Subject: Transmittal of Revision 1 To Service Bulletin Number
V25000-ENG-73-0152.

International Aero Engines SERVICE BULLETIN

ENGINE - INTRODUCTION OF LONGER P2T2 PROBE

V2500-ENG-73-0152

Typical P2T2 Probe
Figure 1

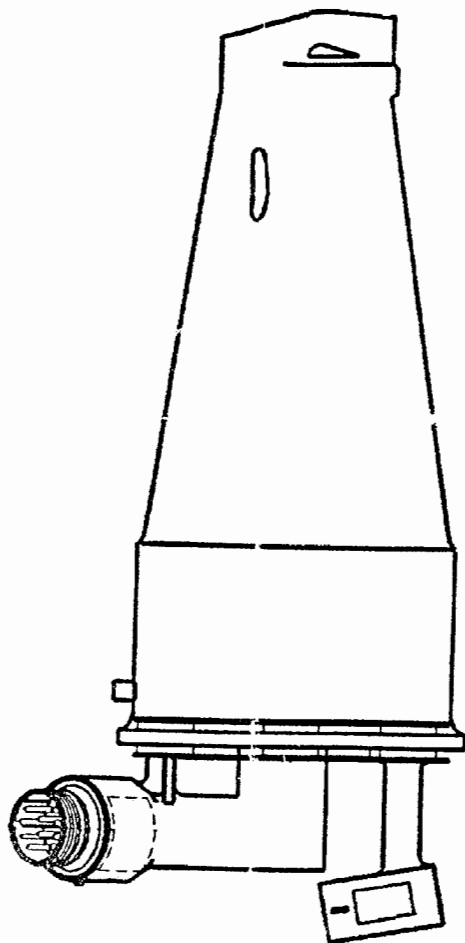
A. Replace Probe P2T2, PN 2A0528 (Vendor, PN 154DB3) with Probe, PN 2A3343 (Vendor, PN 154JU).

- (1) Remove old probe, PN 2A0528 per Reference 3 Chapter/Section 71-11-00-050-011 or Reference 4 Chapter/Section 73-22-11-000-010.
- (2) Install new probe, PN 2A3343 per Reference 3 Chapter/Section 71-11-00-400-001 or Reference 4 Chapter/Section 73-22-11-400-010.

Family Tree - P2T2 Probe
Ref. Catalog Sequence No 73-22-11. Fig. 01 Item 010
Figure 1

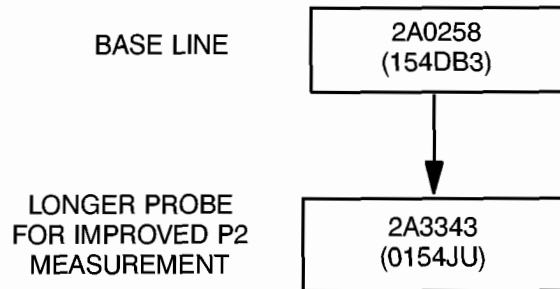
2A3343	1		PROBE	2A0528	(S1)(A)
(0154JU)				(154DB3)	
(73-22-11)				(01-10 A)
